Original Multiplexer State Diagram

Figure 57-6—Multiplexer state diagram

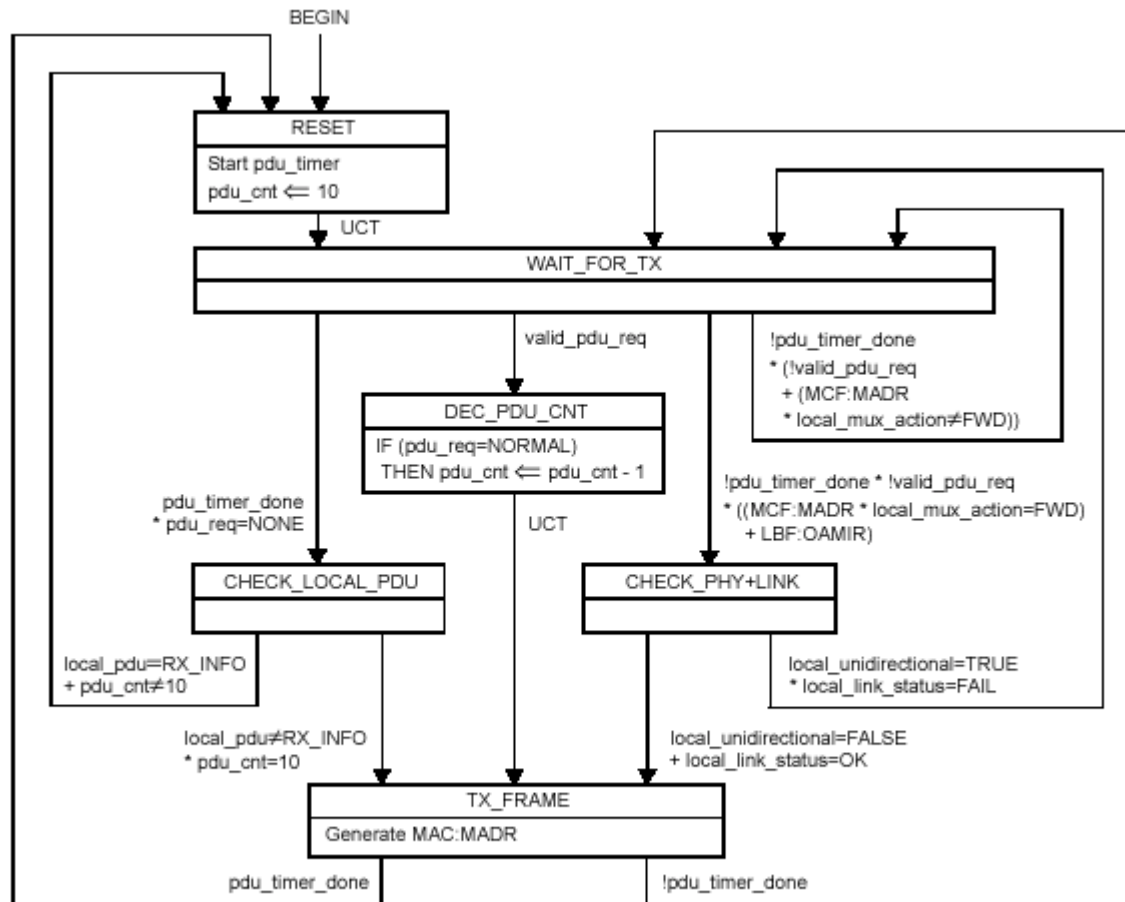
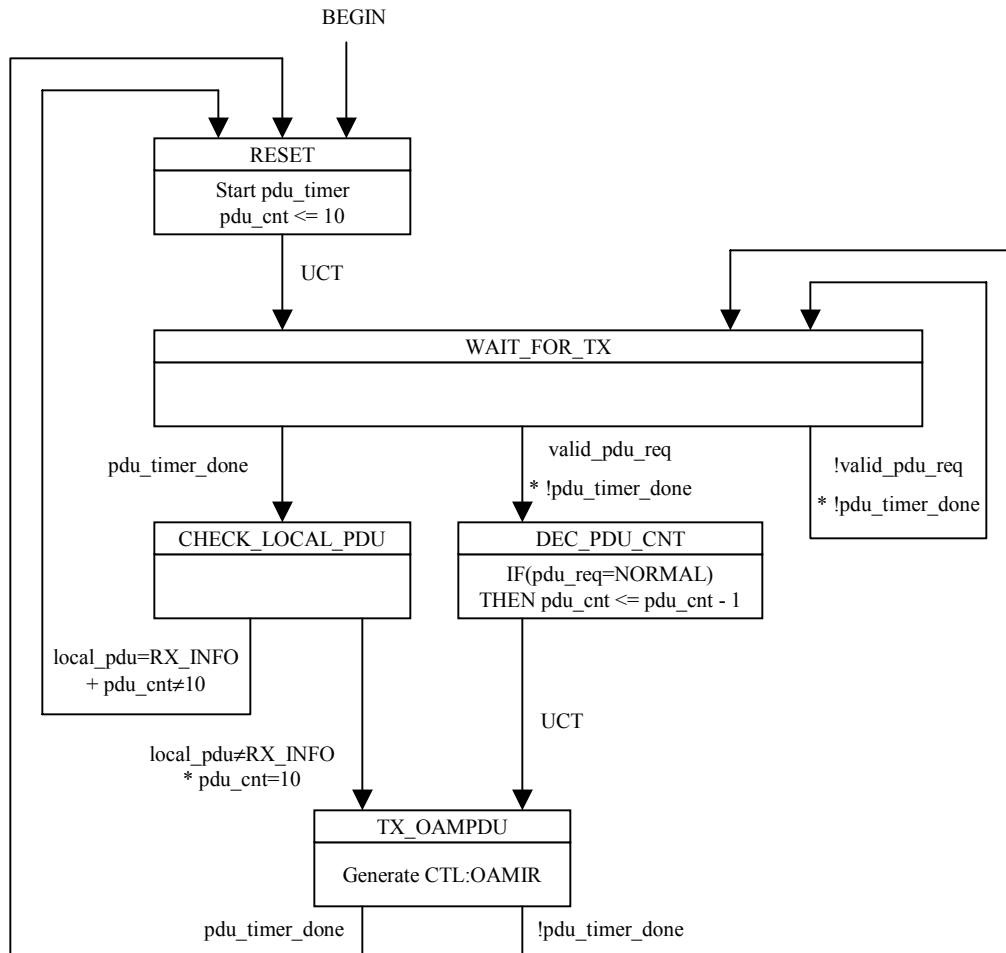
The left hand portion of the diagram is really performing functions that one would expect the Control Block to handle.

The right hand portion of the diagram is doing the multiplexing

Multiplexer state diagram

All references to pdu_timer_done are removed as this is a control block function

All references to valid_pdu_req are removed as all OAM control block frames are valid

Multiplexer now just multiplexes

- Add 57.3.3.1.4 to explain what happens to invalid requests
- **Multiplexer Related**
- Replace the Multiplexer diagram.
- Clause 57.3.3: all text removed. Short blurb mentioning that the WAIT_FOR_TX state is entered when BEGIN is true.

- Clause 57.3.3.1: Condition A) should be removed
- Clause 57.3.3.1.1: Removed but used as the basis for Control Block Text (replace all ref to Multiplexer with Control Block)

- Clause 57.3.3.1.2: Remove all text but the first sentence. Maybe explain that OAMPDU have priority over all other frames.
- Clause 57.3.3.1.3: Remove the last two sentences in the first paragraph

- Clause 57.3.3.1.4: Change title (remove send an OAMPDU or) and remove first paragraph and two conditions
- Clause 57.3.3.2: Remove the last 3 sentences.

Control Block state diagram

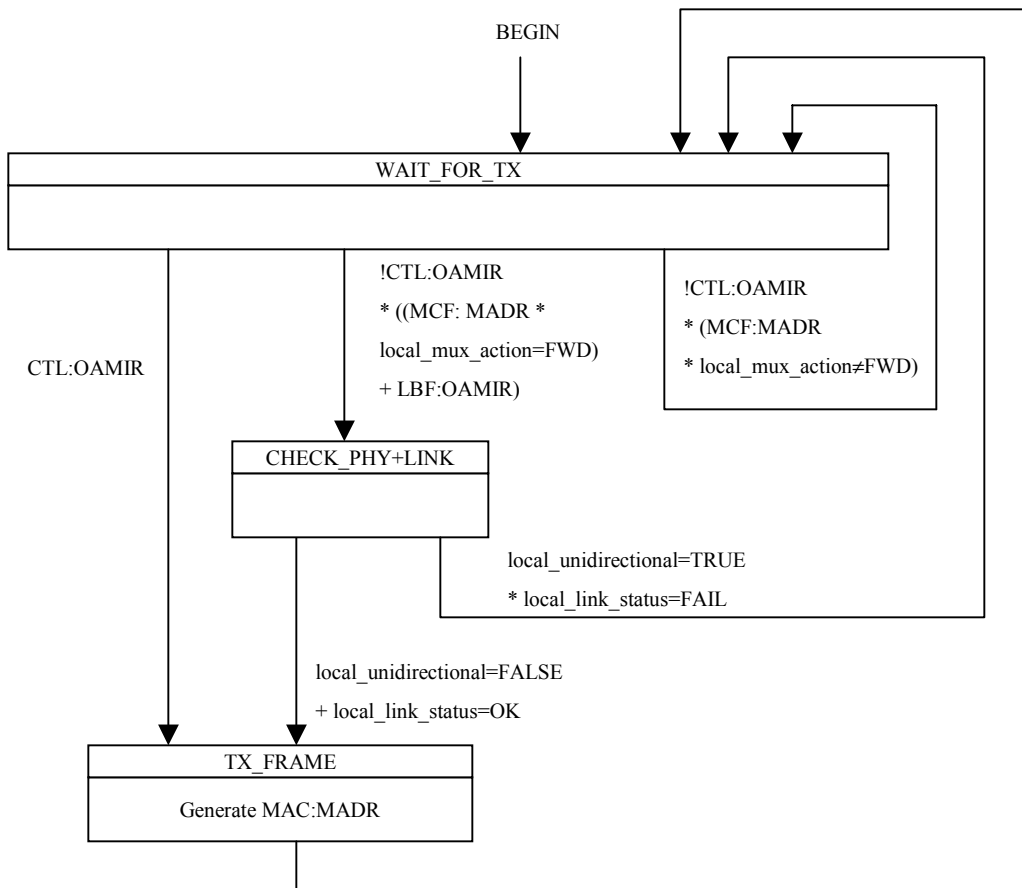
Note: The following changes:

pdu_req

This represents a request to send an OAMPDU and is used within the Control block state diagram

Values: NONE: No OAMPDU.request(source_address,flags,code,data).

CRITICAL: OAMPDU.request(source_address,flags,code,data) while one or more critical link event OAM_CTL.request parameters set (local_dying_gasp, local_link_status, local_critical_event).

NORMAL: OAMPDU.request(source_address,flags,code,data) with no critical link event(s) set

valid_pdu_req: Alias for the following term:

(local_pdu != RX_INFO * pdu_req = NORMAL * pdu_cnt != 0)

+ (local_pdu = ANY * pdu_req = CRITICAL)

By adding the !valid_pdu_req * !pdu_timer_done transition and removing the pdu_req=NORMAL from the pdu_timer_done transition all attempts to transmit an invalid while !pdu_timer_done will have a transition and not get stuck in the WAIT_FOR_TX state

- **Control Block Related**
- Add the control block diagram. It would go somewhere around 57.3.2.2 (possibly 57.3.2.2.1?)
- For consistency each transition would need a text description of what is happening. (basically what would need to be removed from MUX)

- Text from 57.3.3 would be placed below the diagram
 - Add 57.3.3.1.1 to explain pdu_timer (changing all refs to Multiplexer with Control Block)
 - Add 57.3.3.1.2 to explain valid OAMPDUs
